Brevard Conceptual Remedial Action Plan (RAP)

North Carolina Department of Environmental Quality (DEQ) Comments and DuPont Responses

Re: Comments on Conceptual Remedial Action Plan

Former DuPont Brevard Facility EPA ID No. NCD 003 152 329

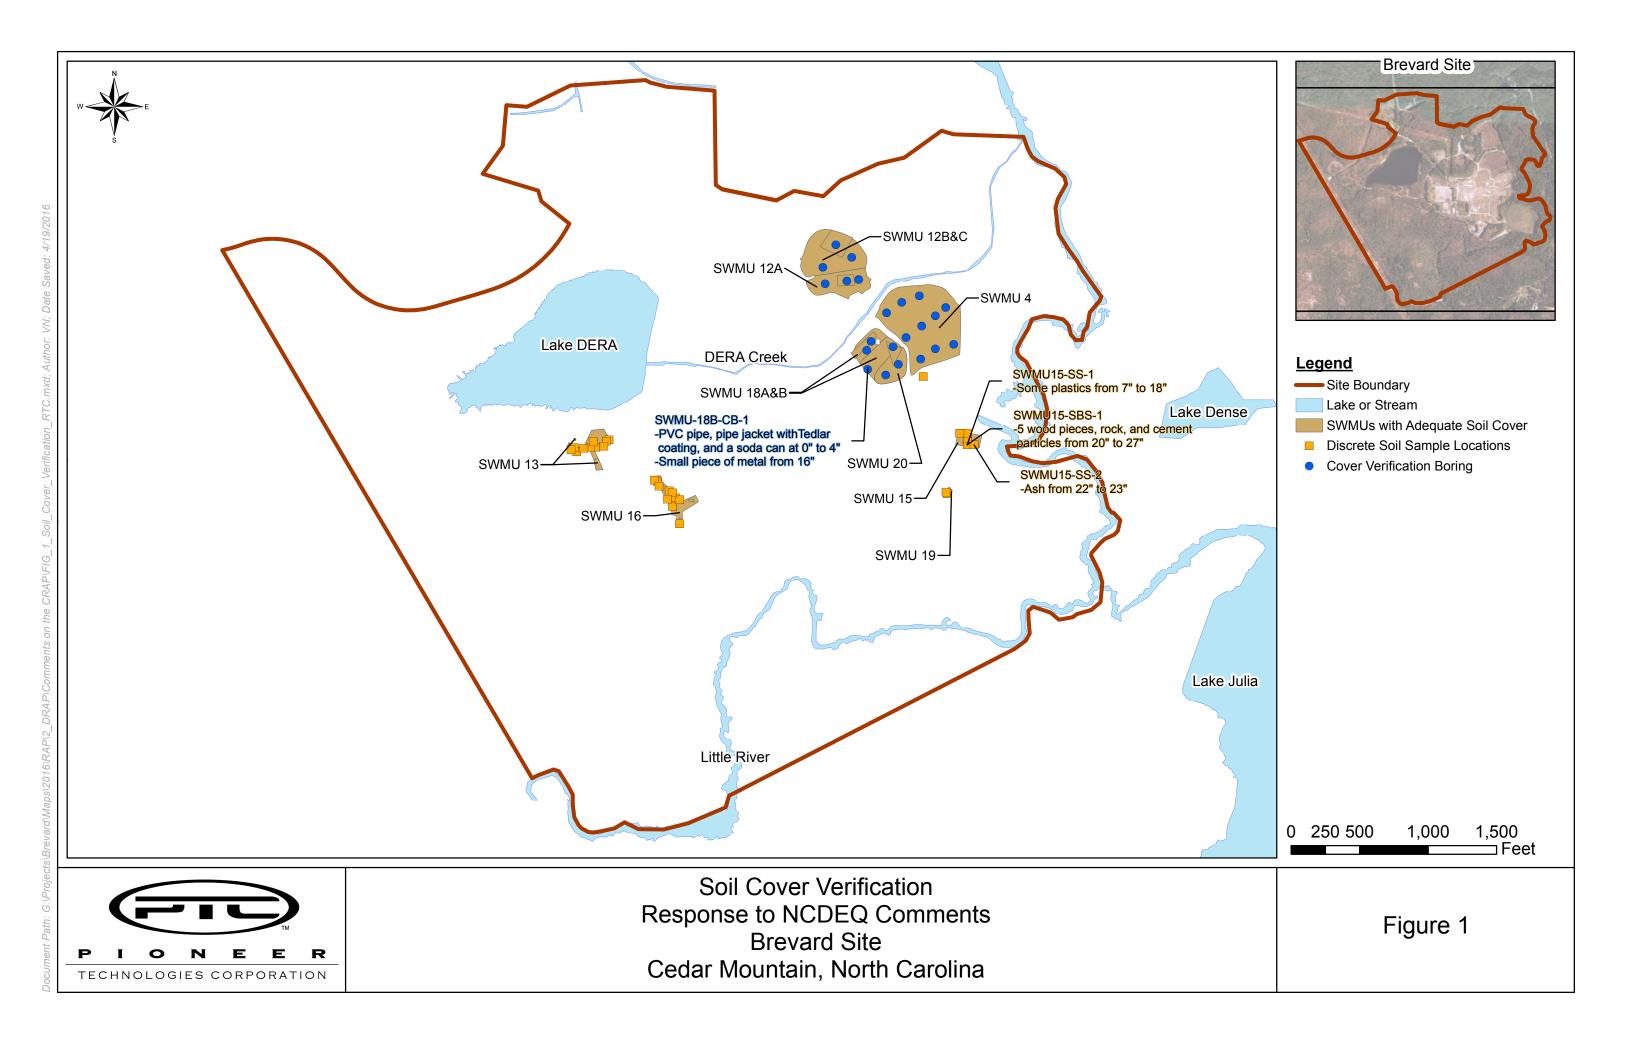
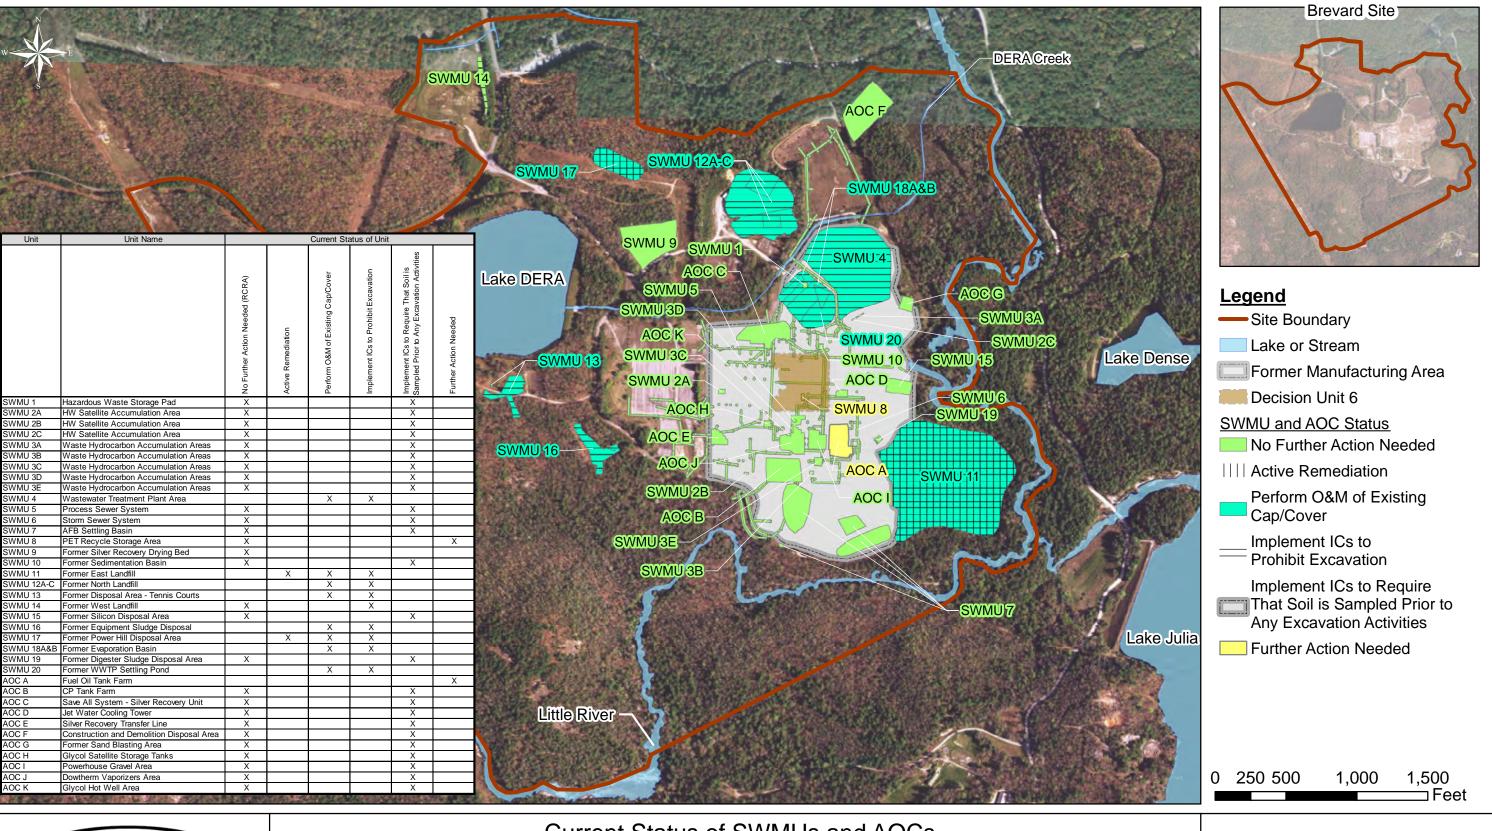
- 1. Section 2.6.6 As indicated in HWS comments on the Remedial Investigation Workplan (RIW) and the Remedial Investigation Report (RIR), data from boring logs advanced during the Phase II RFI and during implementation of the RIW indicate there may not be sufficient cap/cover at some of the SWMUs where waste remains in place. During a December 2015 meeting, DuPont personnel indicated they would consider installation of additional cover materials (e.g. gravel at SWMU 13 of sufficient quantity to use as a potential parking area) at some site SWMUs. If DuPont is still considering this plan, it should be indicated in the RAP.

NCDEQ Comment		DuPont Response		
1.	Section 2.6.6 – As indicated in HWS comments on the Remedial Investigation Workplan (RIW) and the Remedial Investigation Report (RIR), data from boring logs advanced during the Phase II RFI and during implementation of the RIW indicate there may not be sufficient cap/cover at some of the SWMUs where waste remains in place. During a December 2015 meeting, DuPont personnel indicated they would consider installation of additional cover materials (e.g. gravel at SWMU 13 of sufficient quantity to use as a potential parking area) at some site SWMUs. If DuPont is still considering this plan, it should be indicated in the RAP.	 DuPont is not considering installing additional cover materials at any SWMUs on the Site. During the final Site field investigation, soil cores were collected from the following SWMUs: SWMUs 4, 12A, 12B, 12C, 13, 15, 16, 18A&B, 19, and 20 (see Section 5.1.2 of the RIR). The results of the final field investigation indicated that, despite the presence of some miscellaneous debris, adequate soil covers were intact at these SWMUs (see Figure 1). The miscellaneous debris observed in the soil cores were from three of the SWMUs: SWMU 12B (Former North Landfill): Green turquoise plastic was found in one of six soil cores (SWMU-12B/C-CB-3). SWMU 15 (Former Silicon Disposal Area): Plastic, high purity silicone fragments, and/or other materials were found in three of 10 soil cores (SWMU-15-SS-1, SWMU-15-SS-2, SWMU-15-SBS-1). SWMU 18B (Former Disposal Area 8 for evaporation basin wastewater containing zinc chloride): PVC pipe, a soda can, pipe jacket with Tedlar coating, and a small piece of metal were found in one of three soil cores (SWMU-18B-CB-1). This topic was discussed further at a meeting on April 7, 2016 in Raleigh with

Figure 2 (Revised RAP Figure 2-9)

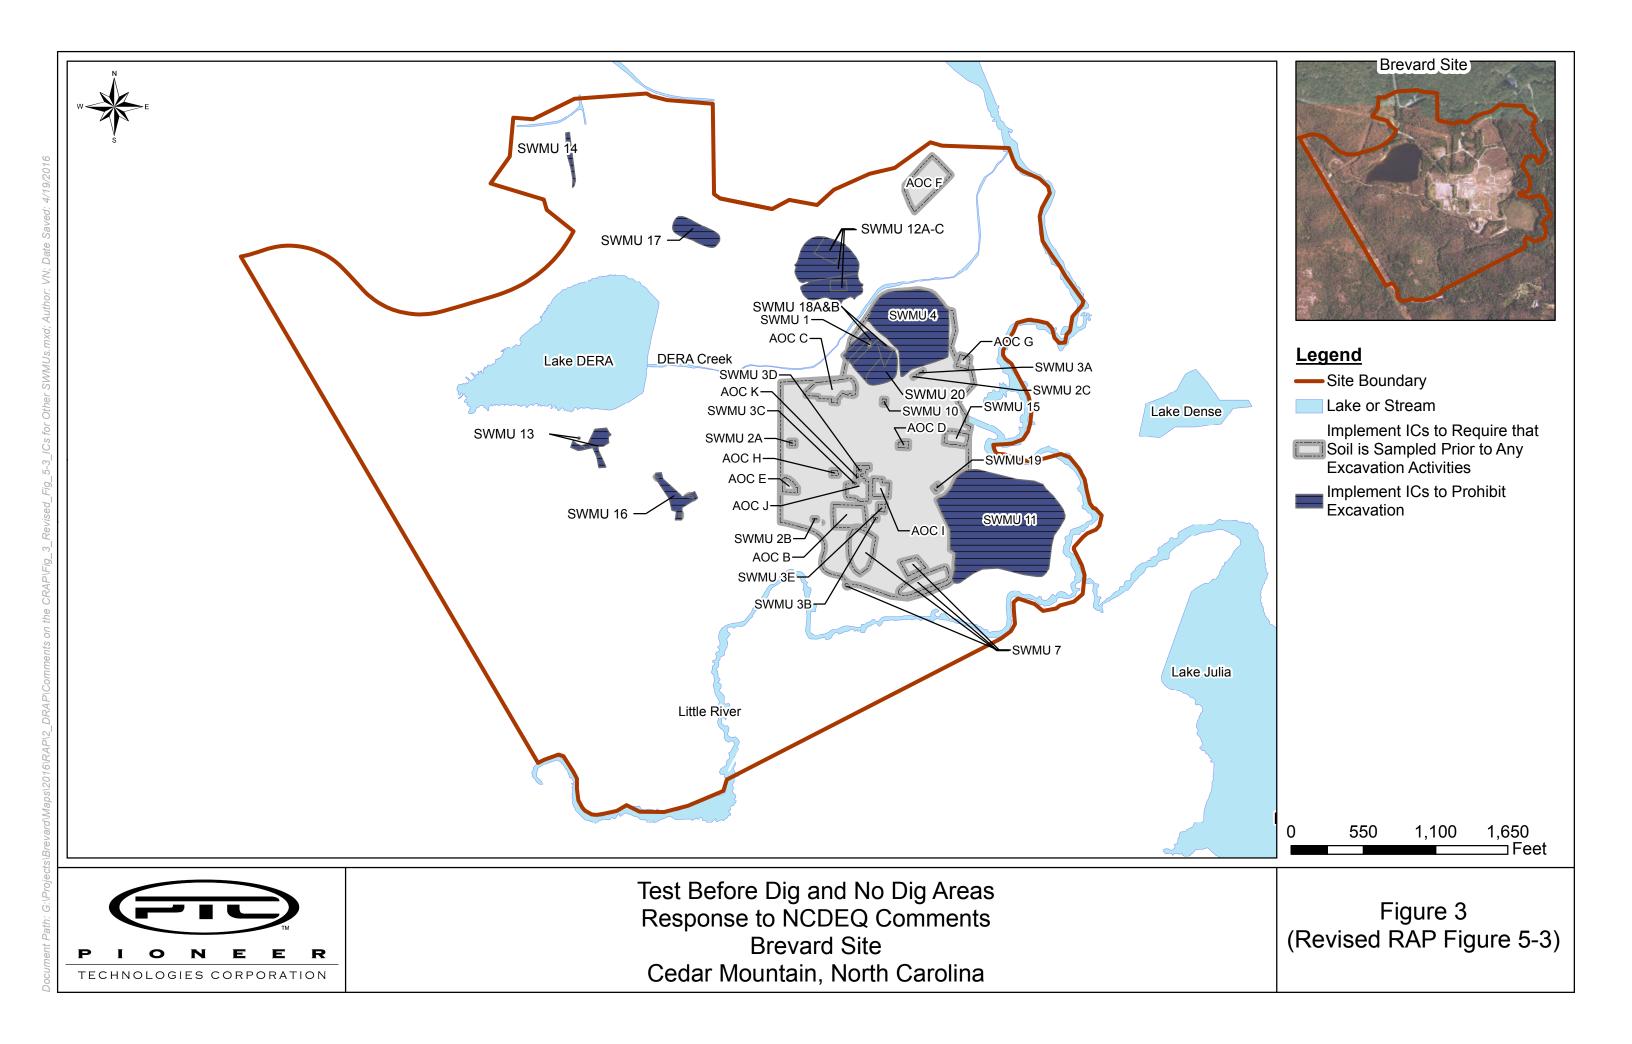
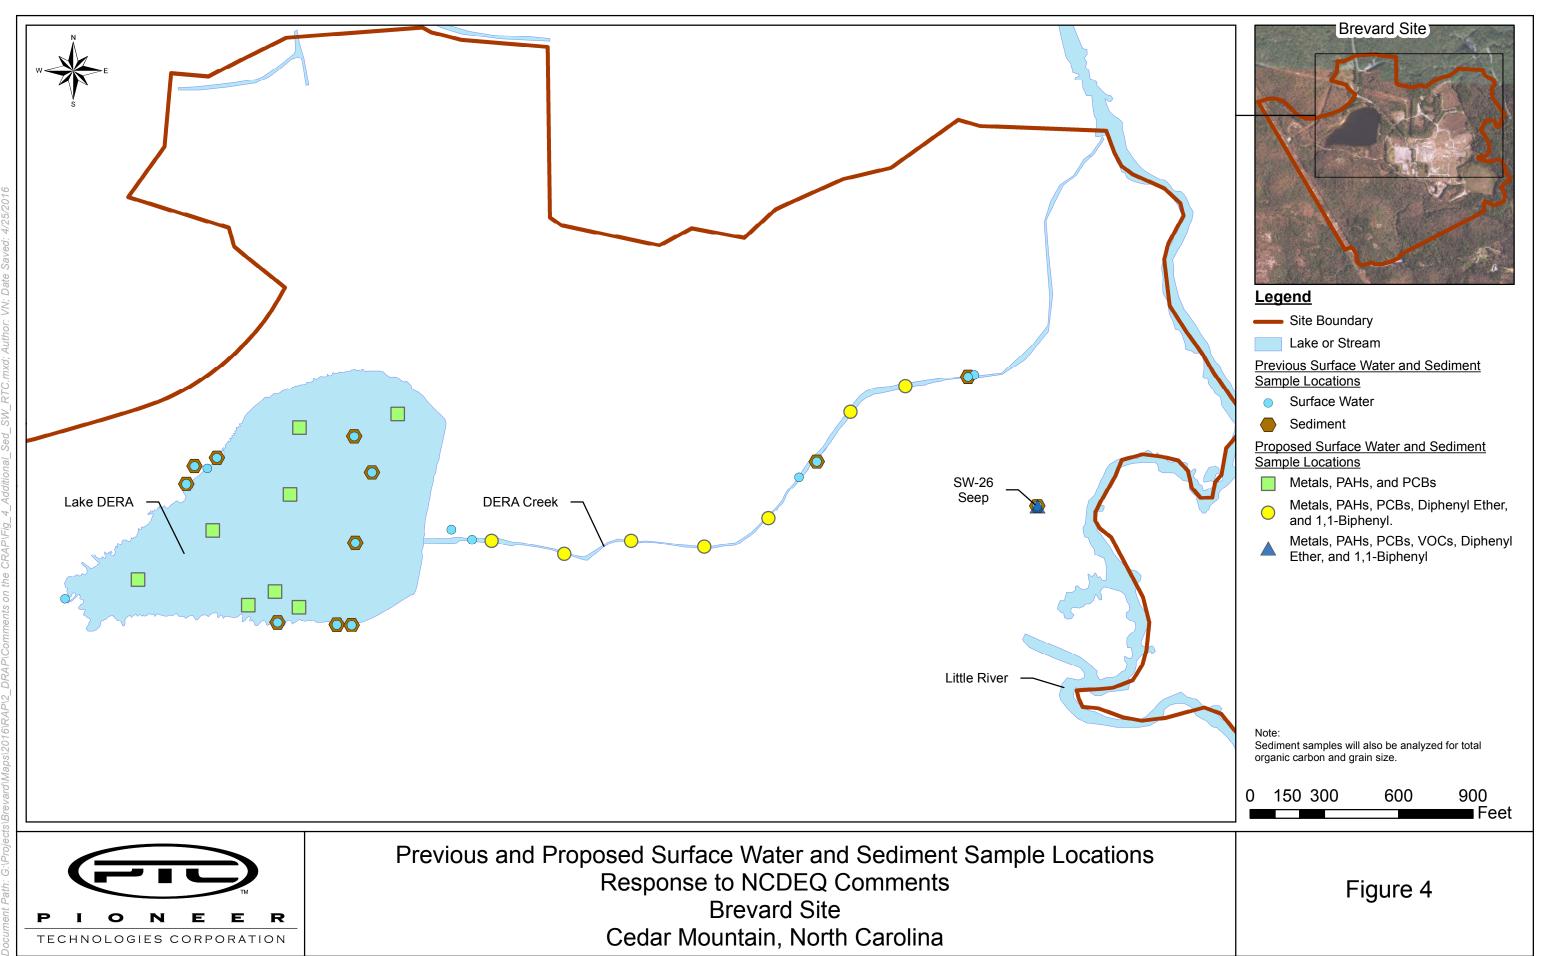
- 5. Section 2.8 AOC 2C should be moved from NFA to the category that requires notification and sampling prior to excavation.
- 6. Section 2.8 AOC F is listed as NFA in the Permit but is listed in the RAP as an area where excavation is prohibited. The status of AOC F should be clarified.

- 7. Section 2.8 See comment 3.
- 8. Section 2.8 AOC A is listed as Further Action Needed in this Section. The status of this AOC should be clarified
- Section 2.12 In August 2015, EPA revised Ecological Screening Values (ESVs) used for evaluating ecological systems. DuPont should use the 2015 EPA ESVs document to develop Remedial Levels based on ESVs for the site.
 https://www.epa.gov/risk/region-4-ecological-risk-assessment-supplemental-guidance

5.	Section 2.8 – AOC 2C should be moved from NFA to the category that requires notification and sampling prior to excavation.	Before the RAP is submitted to NCDEQ, Section 2.8 and Figure 2-9 will be revised to clarify that all SWMUs and AOCs located in the former manufacturing area, including AOC 2C, are considered Test Before Dig Areas and must be sampled prior to any excavation activities (see Figure 2 and Attachment 1).

6.	Section 2.8 - AOC F is listed as NFA in the Permit but is listed in the RAP as an area where excavation is prohibited. The status of AOC F should be clarified.	Before the RAP is submitted to NCDEQ, AOC F will be reassigned from a No Dig Area to a Test Before Dig Area (i.e., Implement ICs to Require that Soil is Sampled Prior to Any Excavation Activities Area), based on discussions with NCDEQ and NCDA&CS (see Figures 2 and 3).

7.	Section 2.8 – See comment 3.	Before the RAP is submitted to NCDEQ, Section 2.8 and Figure 2-9 will be revised to clarify that all of the SWMUs and AOCs located in the former manufacturing area are considered Test Before Dig Areas and must be sampled prior to any excavation activities (see Figure 2 and Attachment 1).

8.	Section 2.8 - AOC A is listed as Further Action Needed in this Section. The status of this AOC should be clarified.	Before the RAP is submitted to NCDEQ, Section 2.8 and Figure 2-9 will be revised to clarify that all of the SWMUs and AOCs located in the former manufacturing area are considered Test Before Dig Areas and must be sampled prior to any excavation activities (see Figure 2 and Attachment 1).
